ENVIRONMENTAL
IMPACT
REPORT

Addendum

Volume 2B: Response To Comments

1988
Revision
to
the
Air
Quality
Management
Plan

FIGURE III-7

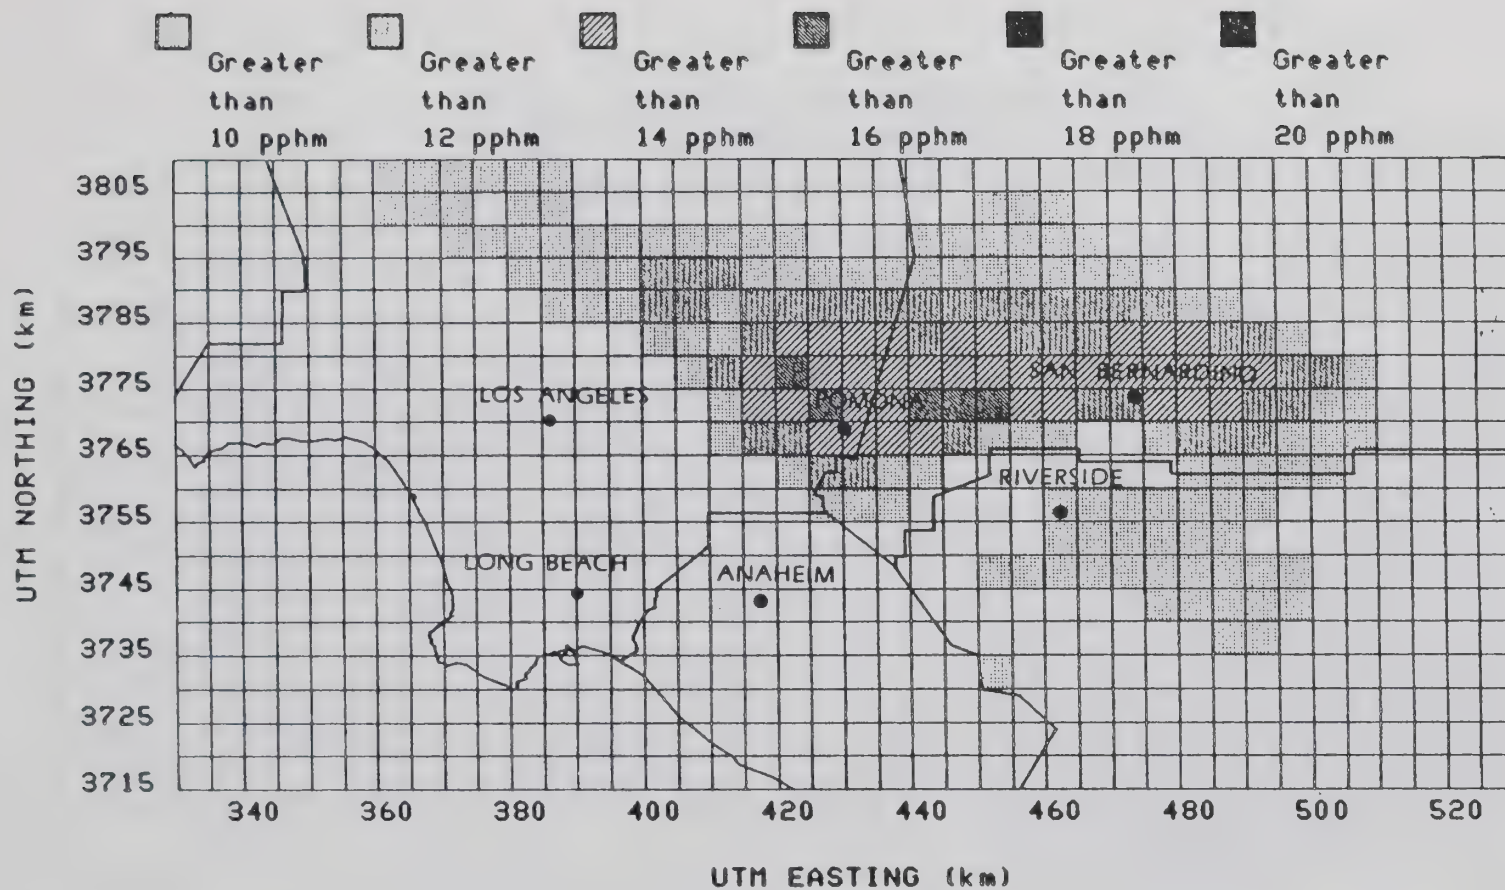
Figure III-7 shows the projected ozone air quality for the 2010 with Tier I and Tier 2 scenario. Although the ROG reductions are comparable to the SCE and WSPA alternatives, the additional significant NO_x reductions result in peak ozone concentrations exceeding 16 pphm in the eastern San Gabriel Valley and western San Bernardino County.

FIGURE III-8

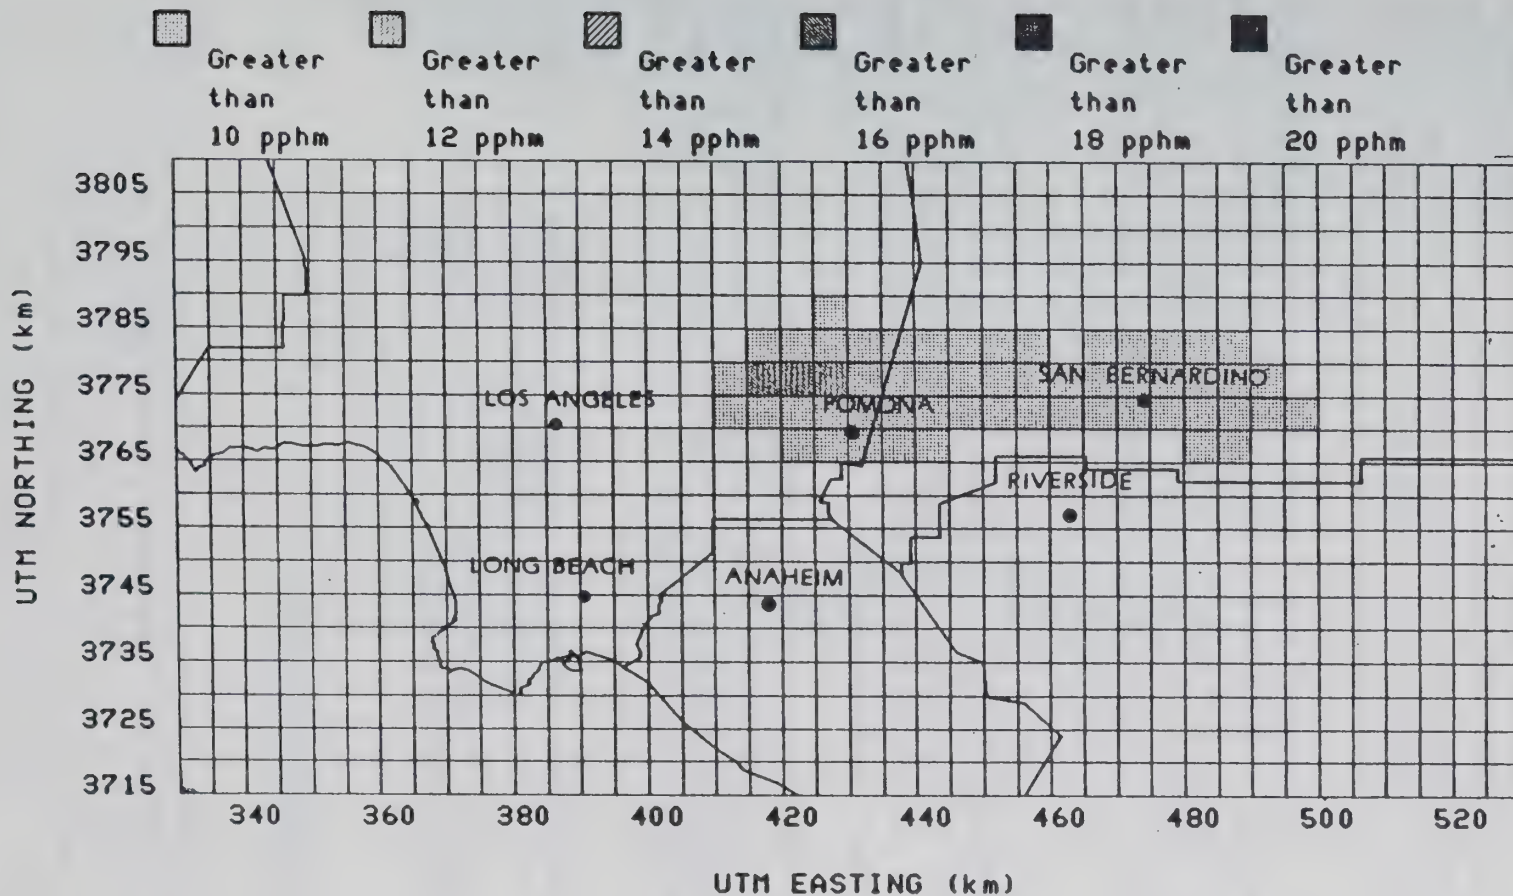
Figure III-8 shows the projected ozone air quality for the 2010 with Tier I, Tier II, and Tier III control scenario. The ozone NAAQS is met everywhere except the eastern portion of the San Gabriel Valley; there it is only exceeded by 0.6 pphm which is within the model's limit of detection.

FIGURE III-10
 UAM Predicted Ozone Isopleth
 (Basinwide Peak Ozone Concentration)

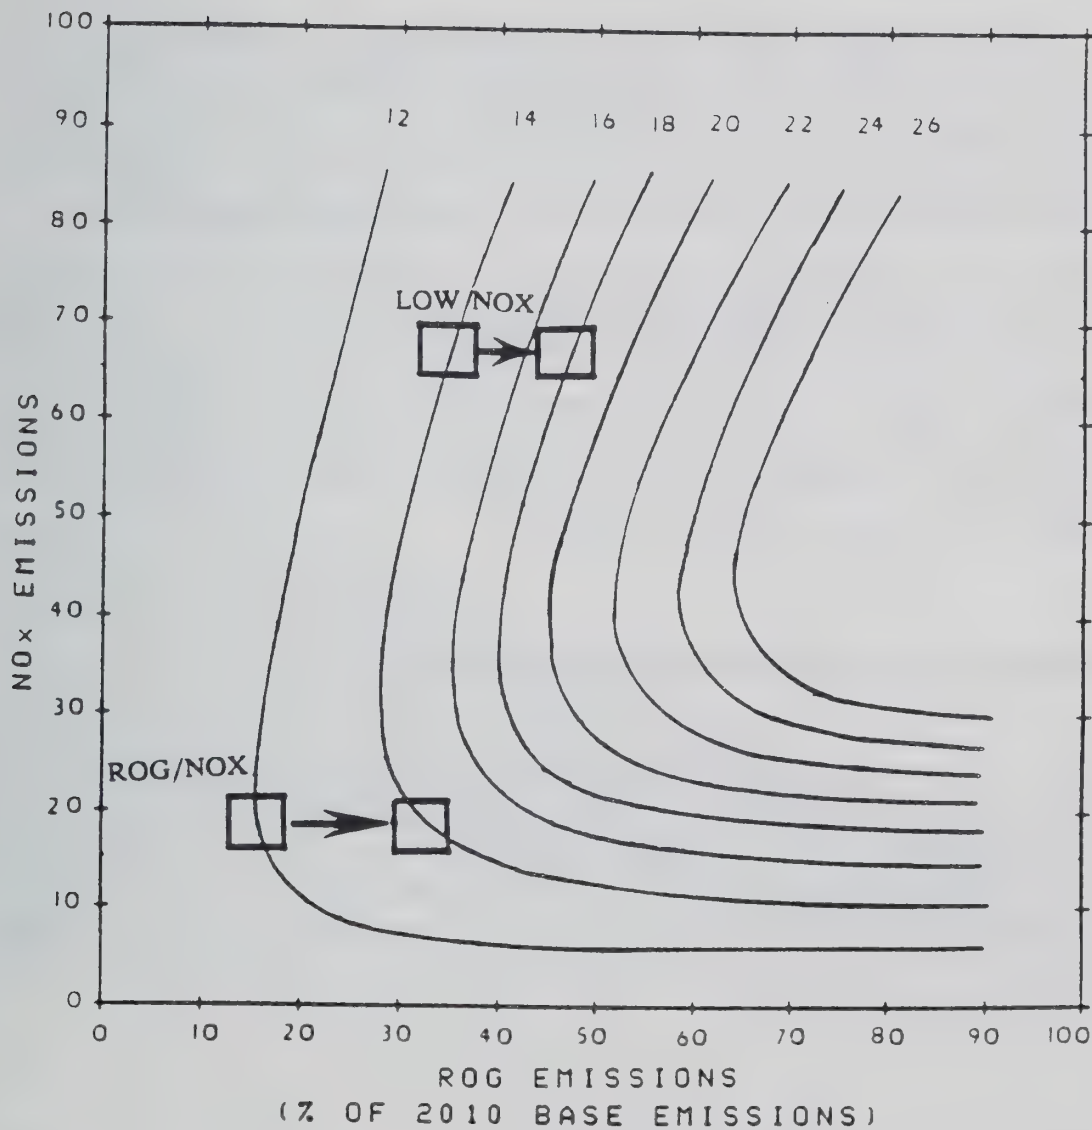
A large number of UAM modeling simulations have been conducted using the June 5-7, 1985 episode along with the across-the-board basinwide reduction of the 2010 baseline ROG and NO_x emissions. Figure III-10 shows the basinwide maximum ozone concentration isopleths¹ based on the results of these simulations. The approximate positions corresponding to the 1988 AQMP Revision and the SCE/WSPA control strategy are also shown on the figure.

These isopleths can be used to illustrate a major concern associated with the control scenarios proposed by SCE and WSPA -- robustness. As indicated by the two arrows shown in Figure III-10, any shortfall of ROG emissions reduction or underestimation of baseline ROG emissions are likely to lead to much higher peak ozone concentrations for the SCE/WSPA control scenarios than for the 1988 AQMP Revision. For example, a 20 percent emission control shortfall in the SCE or WSPA alternatives would result in about a 4 pphm increase in peak ozone levels. A similar shortfall in the 1988 AQMP Revision would result in only a 2 pphm increase.

**FIGURE IV-4**Projected extinction coefficient for peak 24-hour PM₁₀ event

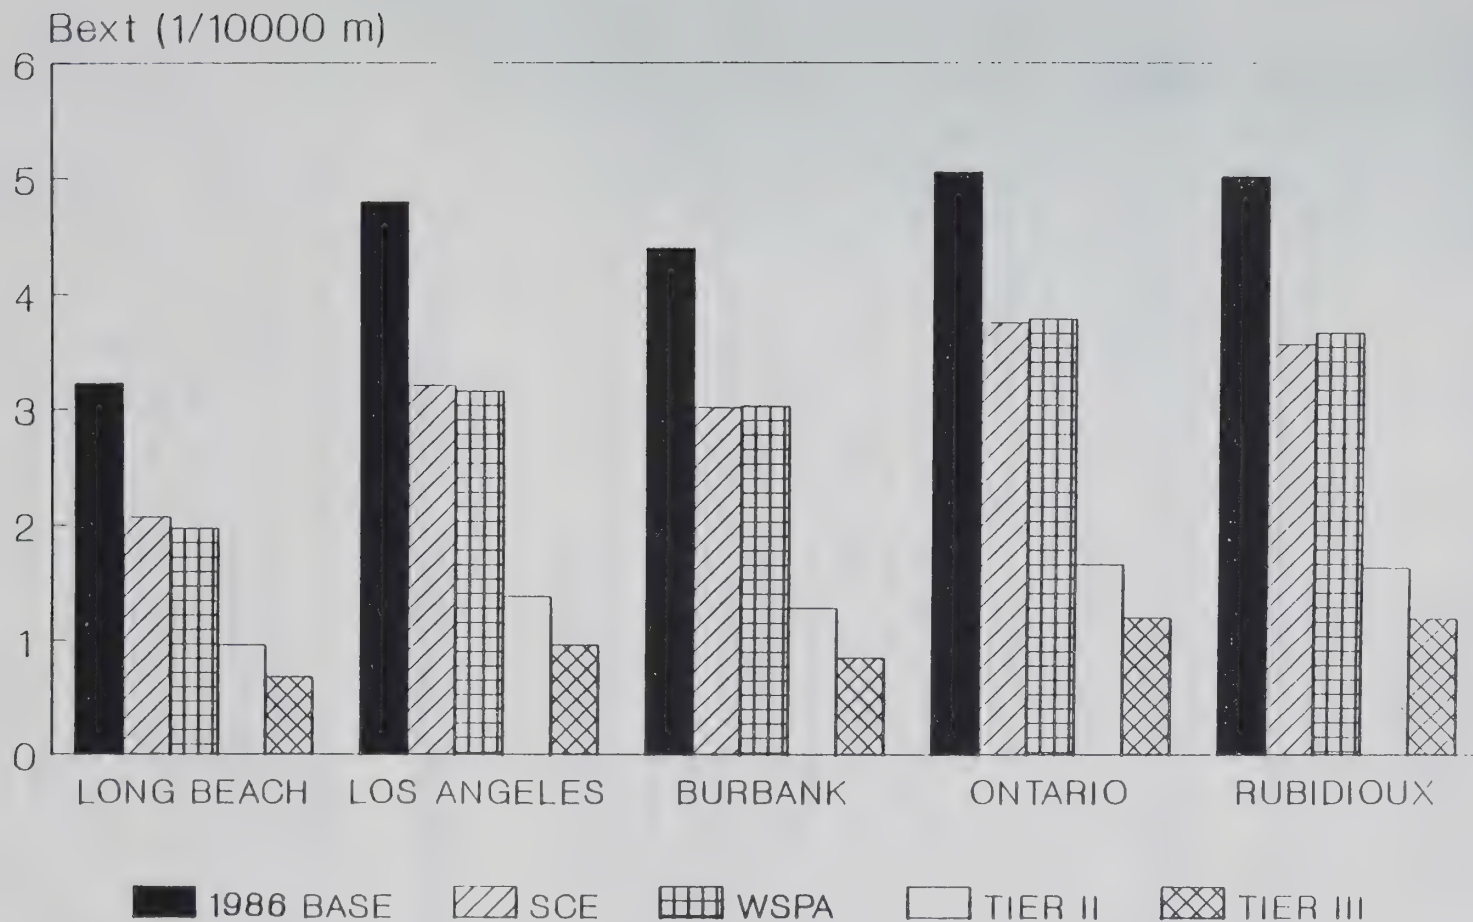
The state standard for visibility requires that the visible range be not less than 10 miles for hours with relative humidity less than 70 percent. There is no 24-hour average or annual average standard. However, Figure IV-4 may be examined for indications regarding future standard compliance. A visual range of 10 miles corresponds to a B_{ext} value of $1.85 \cdot 10^{-4} \text{m}^{-1}$. The SCE and WSPA control strategies are projected to have daily averages of B_{ext} as high as $3.8 \cdot 10^{-4} \text{m}^{-1}$. This corresponds to a visual range less than 5 miles. Therefore, violations of the standard will still occur. Tier II is predicted to produce a daily average B_{ext} value of $1.66 \cdot 10^{-4} \text{m}^{-1}$ at Ontario during the peak PM10 event, which corresponds to a visual range of 11 miles. The highest B_{ext} expected with Tier III controls is $1.20 \cdot 10^{-4} \text{m}^{-1}$ at Ontario, which corresponds to a visual range greater than 15 miles. While these daily averages do not indicate that each hour will meet the standard, it appears that the Tier II scenario will be close to compliance with the standard and that **Tier III controls will meet the state visibility standard**. In addition, this analysis indicates that visual range will be approximately three times greater under the 1988 AQMP Revision than for the SCE/WSPA alternatives.
